ADDENDUM NO. 3Date of Addendum: 7-14-26

PROJECT NAME: City of Alamo – TWDB Project No. HB500
Lift Station No. 1 Wastewater Improvements Project

PROJECT NO: 003-2025BID DATE: JULY 16, 2026

Riser Diagram

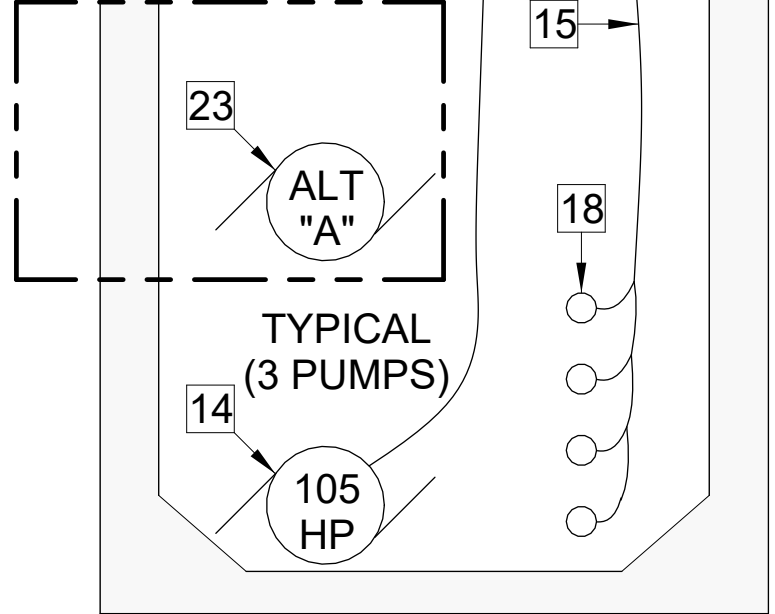
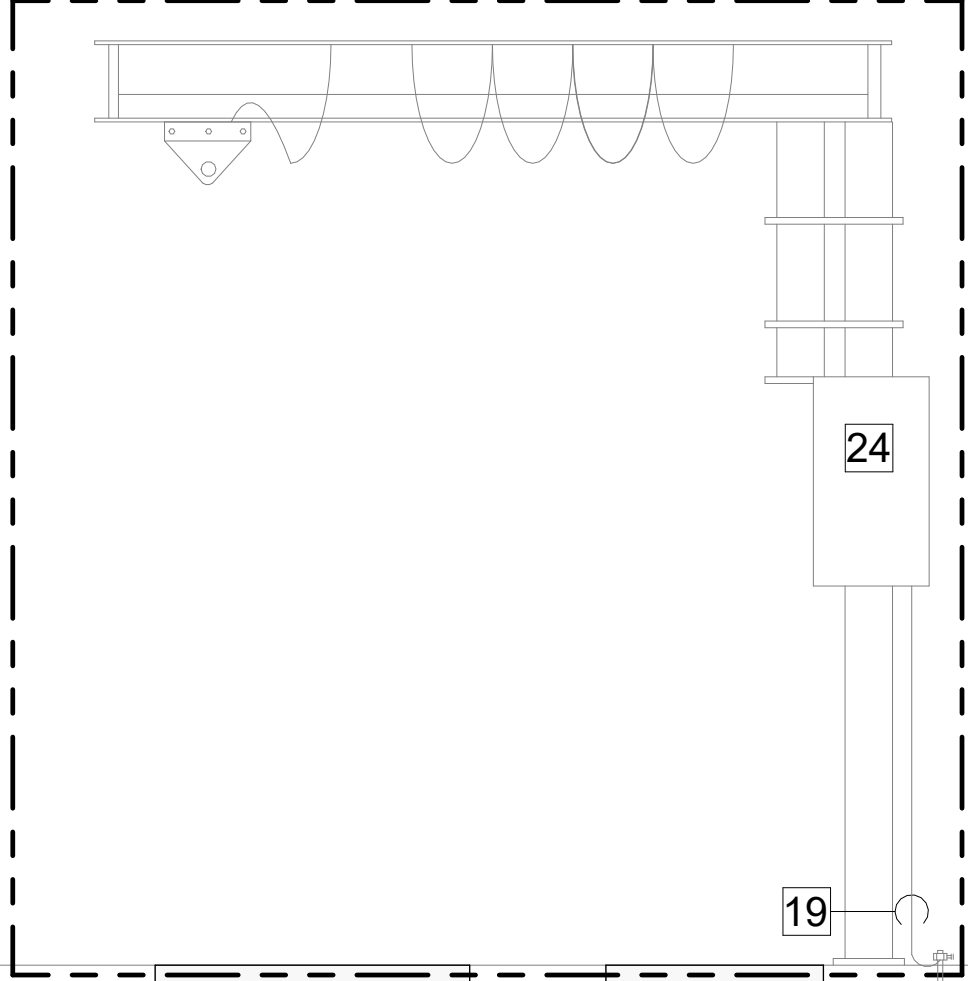
8. Section 00405 Schedule of Unit Price Work – page 4 only – has been attached to this addendum and is required for the use of Section 00407 in bidding submittals.
- 9 See revised sheet regarding amperage from MEP on Sheet E.2
